Camden Planning.

Site: 13 Kemplay Road, London, NW3 1TA

Planning application ref: 2022/1137/P

Application description: Erection of a replacement two storey dwelling with basement following demolition of existing.

Proposed flank elevation, current submission (2022/1137/P)

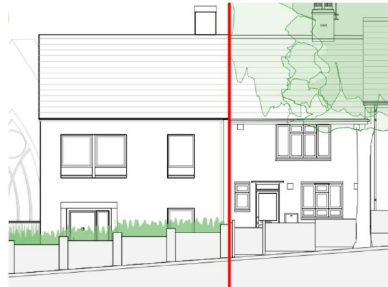
Something has also gone seriously wrong with the flank elevation. As approved, the flank had a small crown roof. This detracted from the full hipped roof form of the terrace, but it had a uniform and symmetrical profile and it didn't look too out of place in the context of the surrounding street scene.

In contrast, the proposed flank elevation would have a bulky rear mansard profile. This markedly contrasts with the front hipped roof slope. It also reads as a clumsy attempt to conceal a large second floor.
